RESPONSE TO REQUEST FOR ADDITIONAL INFORMATION

APR1400 Design Certification

Docket No. 52-046

RAI No.: 176-8089
SRP Section: 03.11 – Environmental Qualification of Mechanical and Electrical Equipment
Application Section: 03.11
Date of RAI Issue: 08/31/2015

Figure 3A-1 A Simplified Flowchart for Calculating the Normal TIDs for Equipment Qualification

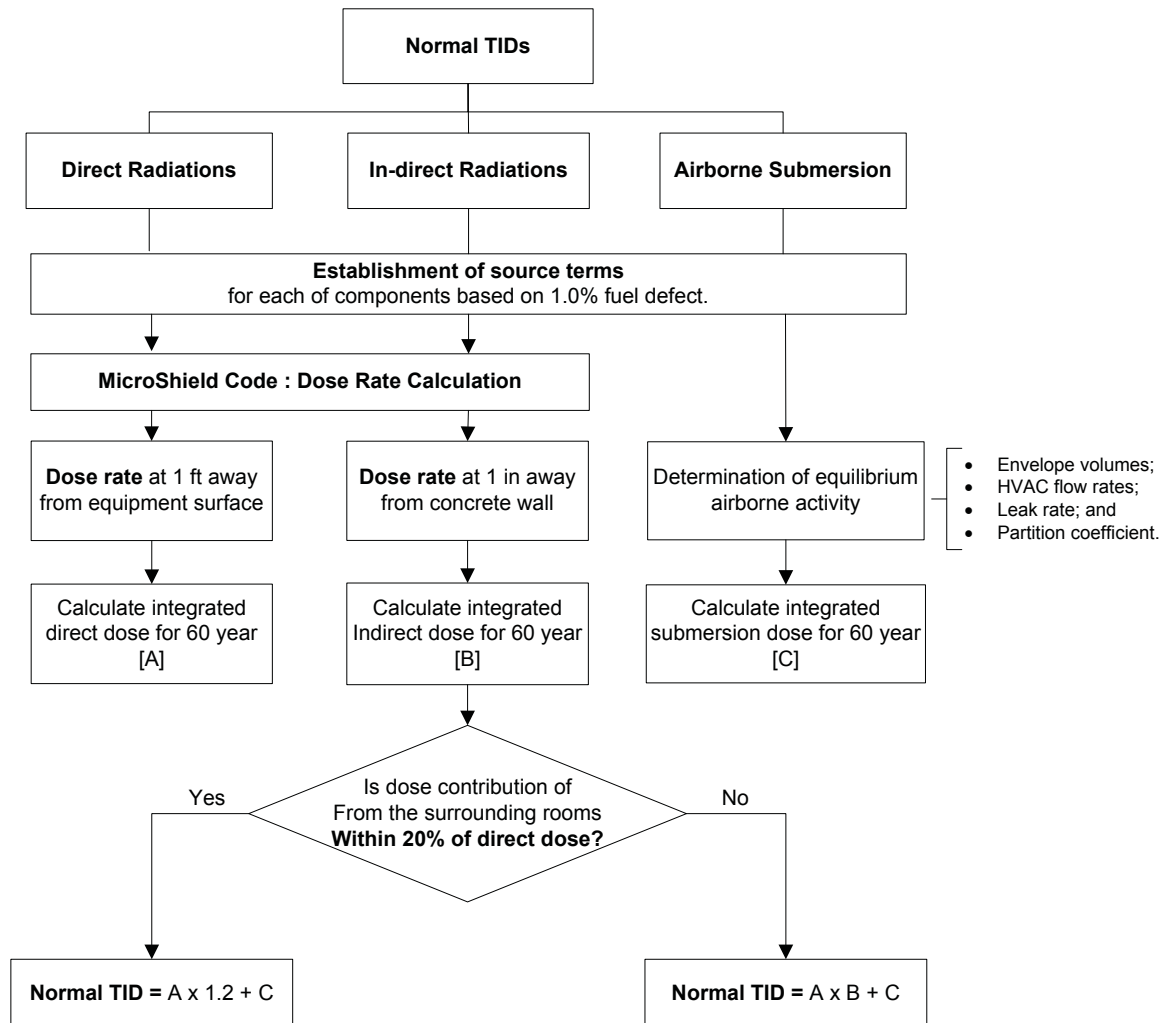
- b. Staff needs a better understanding of how dose rates for equipment qualification were determined in order to determine if the applicant's approach is acceptable. Please describe the approach used for calculating the normal operation one percent failed fuel TID values used for equipment qualification. Begin with the one percent failed fuel source term provided in FSAR Table 11.1-2 and provide a general description of how this source term was used to determine the dose rates in rooms and how the dose from adjacent rooms was determined (were the minimum shield wall thicknesses in Chapter 12 considered? Was 20% just added to the adjacent room regardless of shielding thickness?). Indicate any significant differences in assumptions from assumptions used in creating the Chapter 12 source terms and Chapter 12 radiation zone maps. Then describe what the TID values in FSAR Table 3.11-2 and Table 4 of APR1400-E-X-NR-14001-NP represent (e.g. is it at the maximum dose within the given room or area? Is it the dose where the maximally exposed piece of equipment is located?) Ensure that it is clear how bounding values are being applied for all equipment relevant to equipment qualification. (As part of this response, staff suggests picking a normal operation TID value from Table 3.11-2 (such as for the purification ion exchanger provided for Category C) or a room in Table 4 of APR1400-E-X-NR-14001-NP and explaining how the specific TID value was determined, what specific location was the given dose calculated at, and why it is adequate for all equipment within that region.)

The approach for the above calculations for the determination of the TIDs for equipment qualification consists of three different contributing factors. These factors are summarized below and are presented in a simplified flow chart in Figure 3A-1 of Appendix 3A (provided in Attachment 5):

A simplified flow chart for calculating the normal TID values is presented in Figure 3A-1. As shown in Figure 3A-1, the following three dose contributing factors are considered for the determination of the normal TIDs:

- A 20% margin is added to the direct doses to consider dose contributions from the surrounding areas. If the 20% margin is not bounding the all dose contributions from the adjacent sources, the actual dose rates from the adjacent sources are added to the direct doses.

$$\text{TID} = (\text{TID}_{DI} + \text{TID}_{Sub}) \times 1.1 \quad (\text{Eq. 4}).$$
